Office Action Summary	Application No. 10/757,776	Applicant(s) BOEHM ET AL.	
	Examiner DIANNE DORNBUSCH	Art Unit 3773

DETAILED ACTION

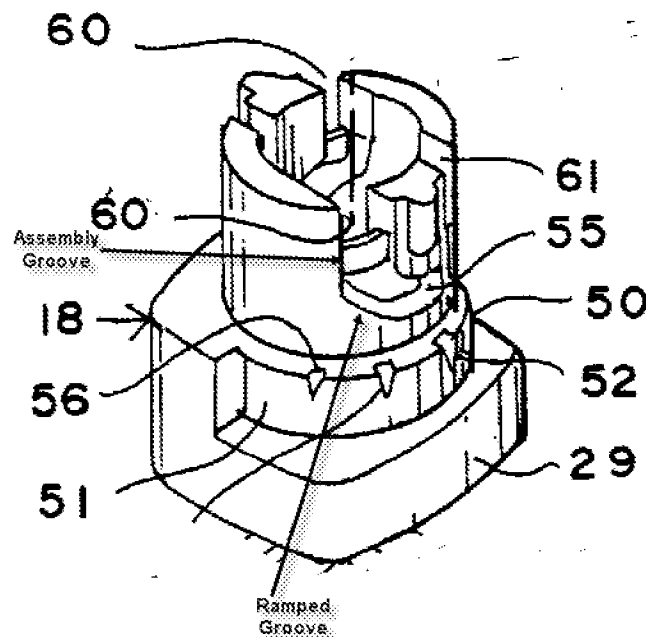
Abulhaj discloses a lancet with an adjustable depth mechanism in which a cap (18) is adjustable by a pin/groove mechanism (Fig. 15-16 where the pin (31) enters the groove seen in the figure below) where the groove has an assembly groove (see figure below) extending in a first direction (it extends longitudinally from the proximal end towards the distal end) and a ramped groove (see figure below) extending in a second

direction (it extends diagonally as seen in the figure below) deviating from the first direction (see figure below).

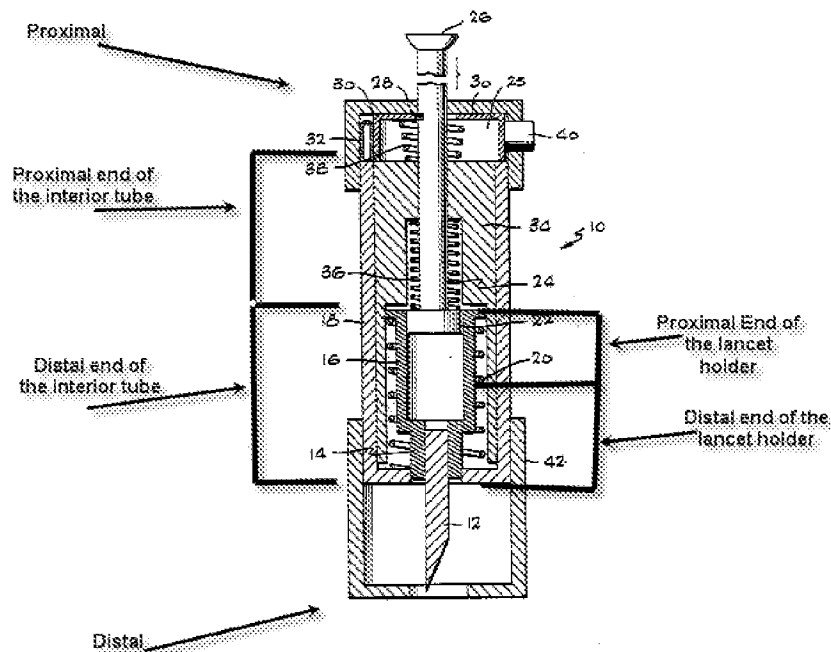
Hofert discloses a rearward body assembly of a lancing device that can propel a lancet (12) into a lancing surface, the rearward body assembly comprising: a lancet holder (16) comprising one or more retaining features (14) and one or more spring surfaces (the outer area and the top surfaces of the lancet holder are spring surfaces since the surface is in contact with the springs) at the distal end (see figure below where the distal end is labeled) and one or more lancet holding features (the internal wall of 14 and 16 as seen in the Figure) at the proximal end (the proximal portion of the holding features is at the proximal end as defined in the figure below); an interior tube (34) comprising an open end (proximal end as seen in the Figure) and a slotted end (distal end where it is stepped and has an opening as seen in the Figure) through which the

one or more retaining features extend (see the Figure where it extends out when the lancet holder is propelled out), the interior tube (34) being adapted to slidably engage the lancet holder (16) (the lancet holder is placed inside the inner tube as seen in the Figure); a finger cover (18) (note that the finger cover according to applicant's drawings is a collar that goes over the interior tube as best seen in Fig. 3 of the current application) arranged along a periphery of the interior tube (see Figure); an internal compression spring (36) comprising a first end and a second end (see Figure), the first end of the internal compression spring (36) being adapted to act on the slotted end of the interior tube (34) (the proximal end of the spring is in contact with the slotted area as seen in the Figure) and the second end of the internal compression spring (36) being adapted to act on the one or more spring surfaces of the lancet holder (16) (the distal end is in contact with the lancet holder so when a force is applied on the spring it will act on the spring surfaces); a retainer (42) comprising a slotted surface (opening where the finger collar enters) at the distal end of the interior tube (see figure below) through which the one or more retaining features extend (see the Figure where it extends out when the lancet holder is propelled out); a rearward body (combination of 24 and 22), the rearward body engaging the retainer (it is indirectly engaged to the retainer); wherein longitudinal movement of the rearward body away from the interior tube compresses the interior compression spring (36) (by pulling on the rearward body it can compress the interior tube) (Col. 3 Lines 5-10) and an external compression spring (20) comprising a first end and a second end (see the Figure), the first end comprising a reduced coil diameter that engages the one or more retaining features (14) of the lancet holder (16)

as seen in the Figure, the first end of the external compression spring being adapted to act on the lancet holder (the spring is holding the lancet holder which will act on it to cause the deployment of the lancet) and the second end of the external compression spring being adapted to act on the slotted surface of the retainer (the spring is compressing on the retainer therefore it is acting on the slotted surface); and wherein the one or more spring surfaces of the lancet holder engages both the internal compression spring and the external compression spring (see Figure where the one or more spring surfaces engages indirectly to both spring).
